CAP MEETING – 10 NOVEMBER 2021
ITEM 9.2

DEVELOPMENT NO.:	21019844
APPLICANT:	Bird in Hand Winery
ADDRESS:	150 PFEIFFER RD WOODSIDE SA 5244
NATURE OF DEVELOPMENT:	Variation to 18/828/473 to increase the floor area and the height of the cellar door, restaurant & function facility and internal alteration
ZONING INFORMATION:	Zones: <ul style="list-style-type: none"> • Productive Rural Landscape Overlays: <ul style="list-style-type: none"> • Environment and Food Production Area • Hazards (Bushfire - Medium Risk) • Heritage Adjacency • Hazards (Flooding - Evidence Required) • Limited Land Division • Mount Lofty Ranges Water Supply Catchment (Area 2) • Native Vegetation • Prescribed Water Resources Area • Water Resources
LODGEMENT DATE:	29 Jul 2021
RELEVANT AUTHORITY:	Assessment Panel at Adelaide Hills Council
PLANNING & DESIGN CODE VERSION:	2021.10
CATEGORY OF DEVELOPMENT:	Code Assessed - Performance Assessed
NOTIFICATION:	Yes
RECOMMENDING OFFICER:	Doug Samardzija Statutory Planner

- Increase the height of the building from 15.24m to 18m, an increase in height by 2.76m
- Increase the floor area by 150m², which includes a combined increase in the ground floor and first floor areas

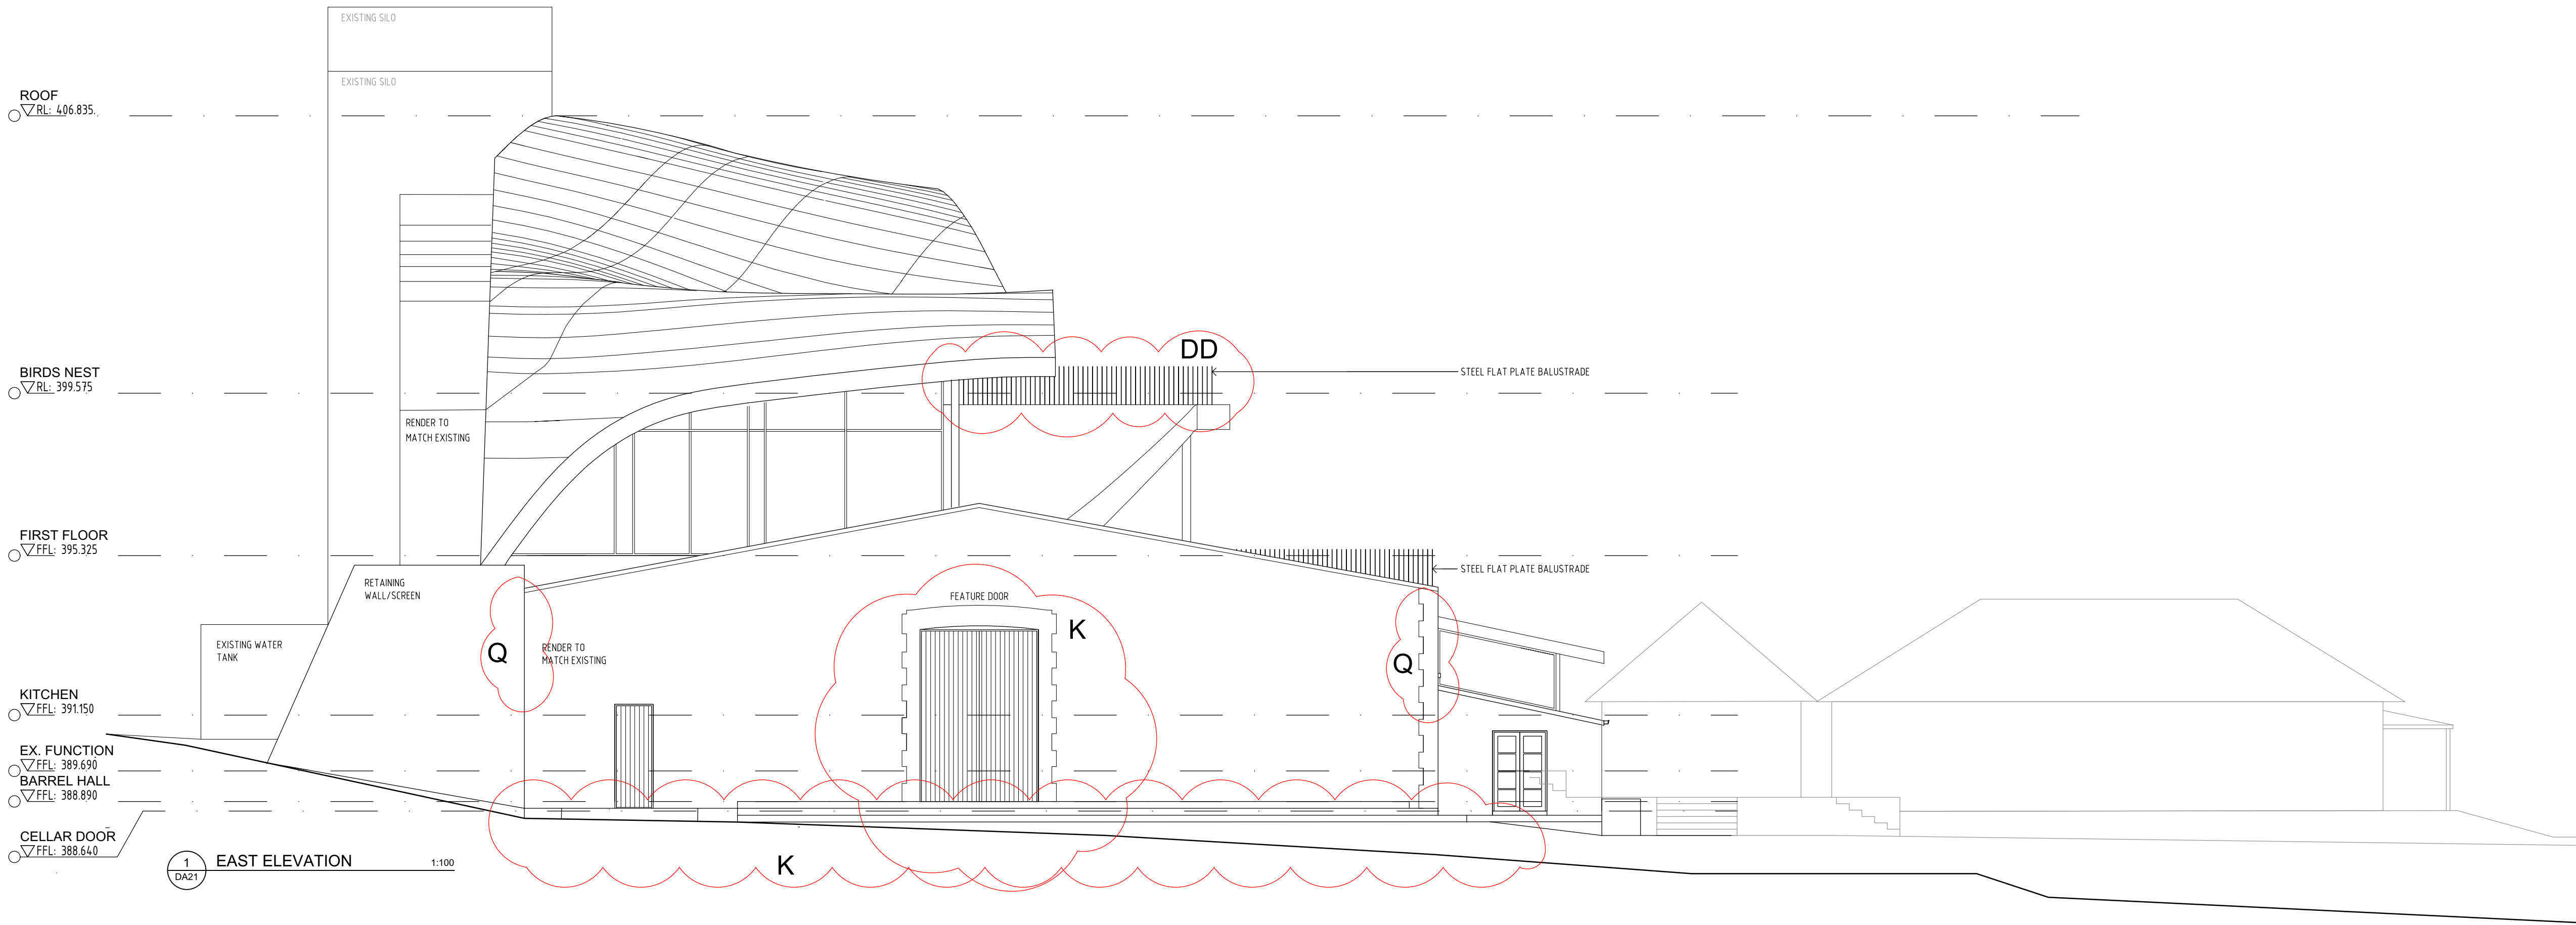
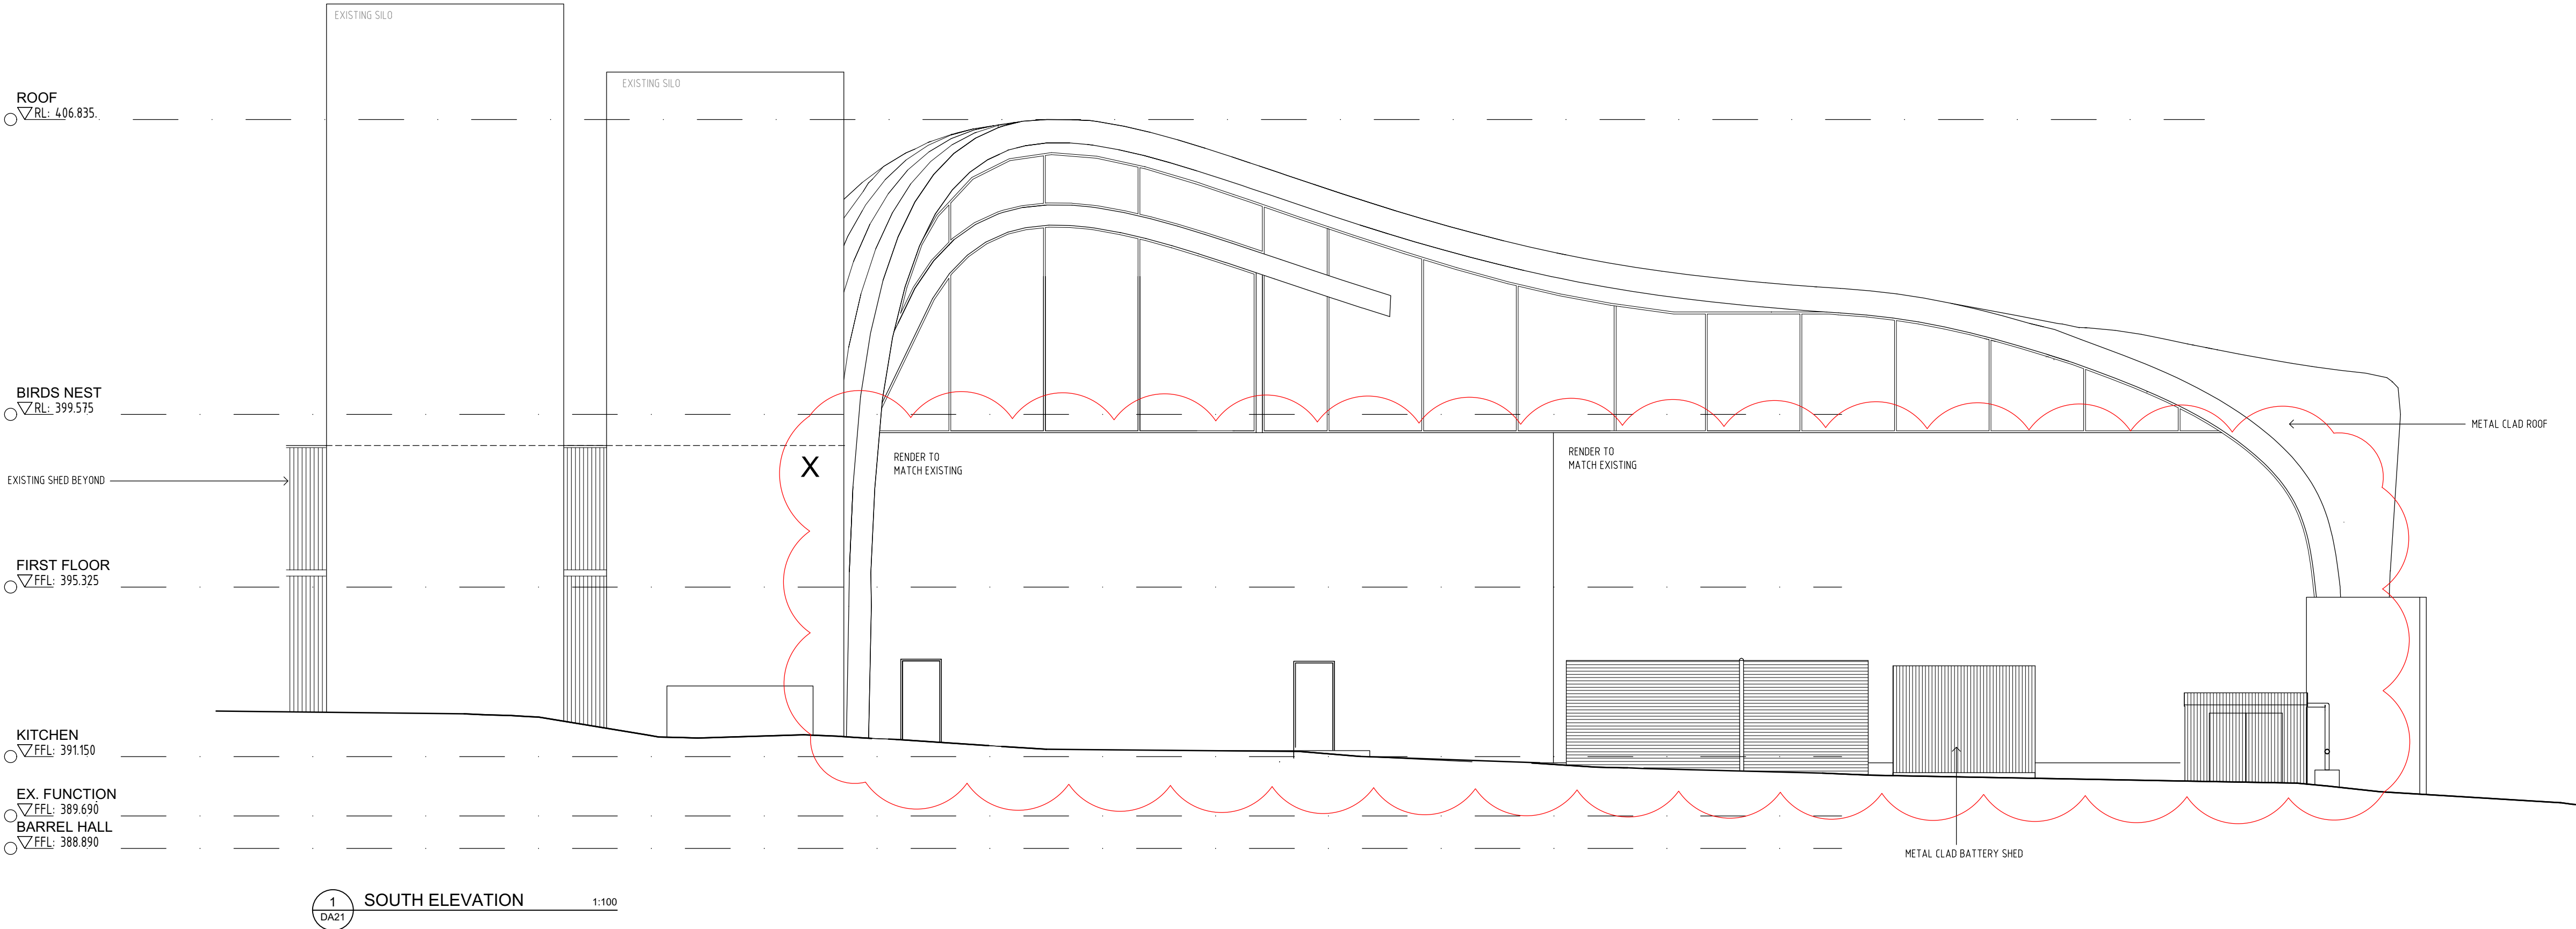
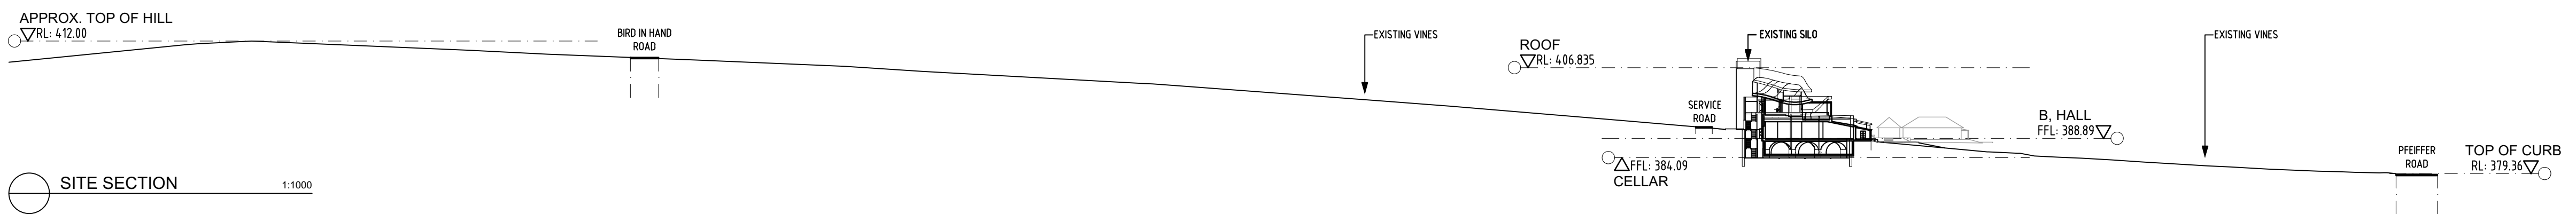
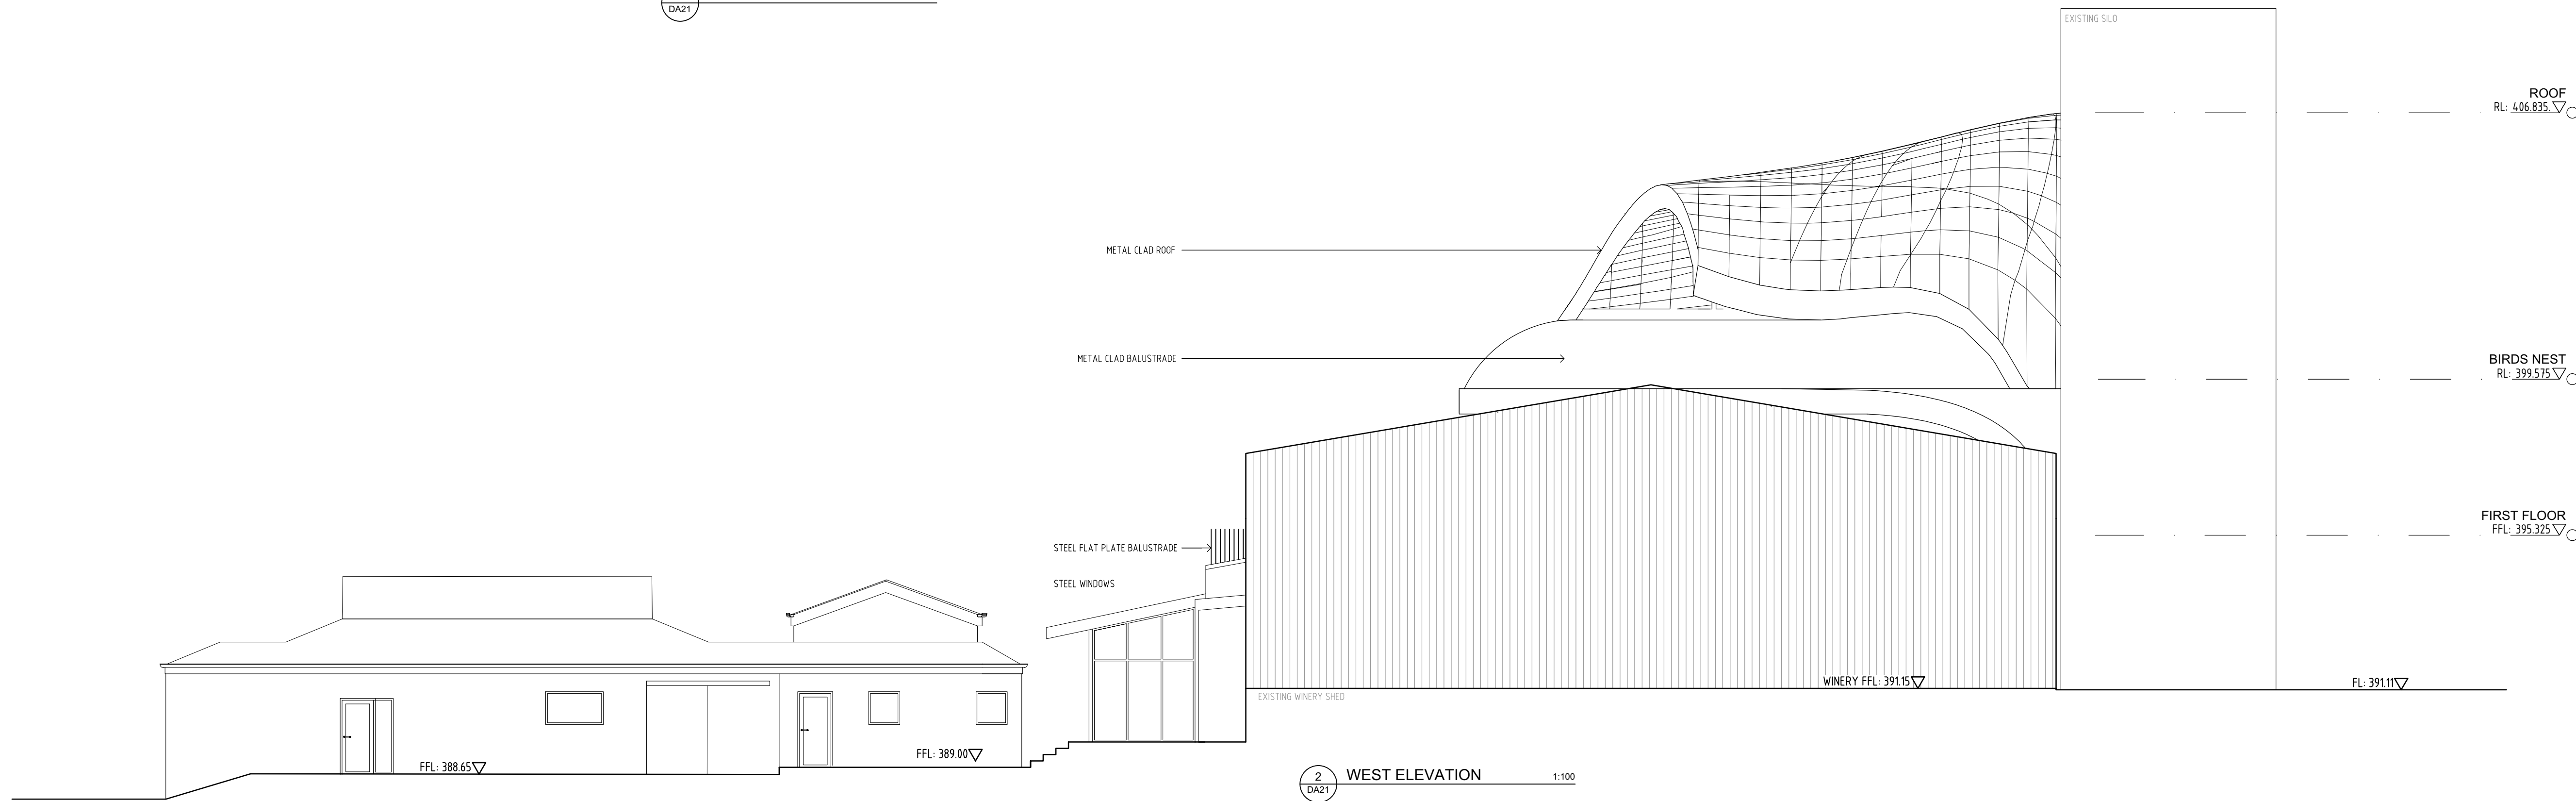
- The Basement/Cellar*
- (a) location of the "everyday access stair" moved to north eastern corner (no personal lift access to this level);
 - (b) vehicle lift added;

- (c) work/store room created;
 - (d) length of the floor level increased in length in an easterly direction by 3145 mm;
 - (e) 4000 mm high vaulted arched distressed plaster ceiling and columns;

- (i) length of the tasting room and barrel hall increased in length in an easterly direction by 3145 mm;
- (j) barrel hall floor height increased by 250 mm (requiring 2 steps down to tasting room and main entry)

- (k) the eastern side of the barrel hall feature door increased in height and external steps and ramp reconfigured to suit;
- (l) vehicle lift added;
- (m) location of the everyday access stair position changed;

- (t) length of the floor level increased in length in an easterly direction by 3145 mm;
- (u) location of the everyday access stair position changed;
- (v) fire stair added to southern wall;
- (w) overall roof height increased to RL 406.835;
- (x) southern wall is to be rendered to match the existing wall;
- (y) stair case up to mezzanine floor relocated to the on southern wall with curving roof above;
